DESCRIPTION: FIELD SPLICE DETAILS

STRUCTURE: U.S. 5 over I-91 Bridge No. 19A Putney County of Windham	DRAWN: WJF	DATE: 01/07	
	CHKD: DO	DATE: 01/12	
LOCATION: Putney	JOB NO.	DWG NO.	
PROJ NO. IM 091-1(31)	438	X1	
CUSTOMER: VT AOT		REV. △

SHOP DRAWINGS ARE REVIEWED UNLESS NOTED OTHERWISE
SUBMISSION NO.N
S.ZAK ASSOCIATES
TRANSPORTATION REPORTS
SHOP DRAWING
STRUCTURE FOUNDATIONS
SUBMITTED
DATE 2/9/10
SIGNATURE
REVIEW BY STATE IS ONLY FOR THE SOLE PURPOSE OF ENSURING THAT THE SUBMITTAL COMPLIES WITH DESIGN CONCEPTS OF RESPONSIBLE FOR DIMENSIONS, FABRICATION, CONSTRUCTION METHODS COORDINATION OF SUB-TRADES, DETAIL DESIGN OF COMPONENTS AND ERRORS OR OMISSIONS ON SHOP DRAWINGS

10 - FIELD SPLICE DETAIL - X1M2

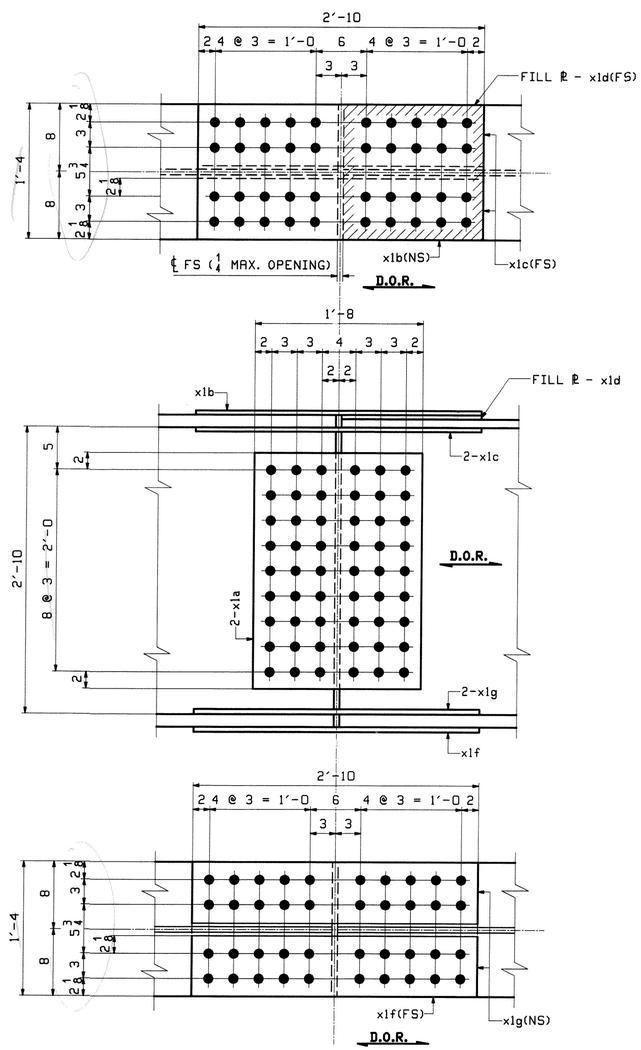
CHECK THICKNESS, # BOLTS
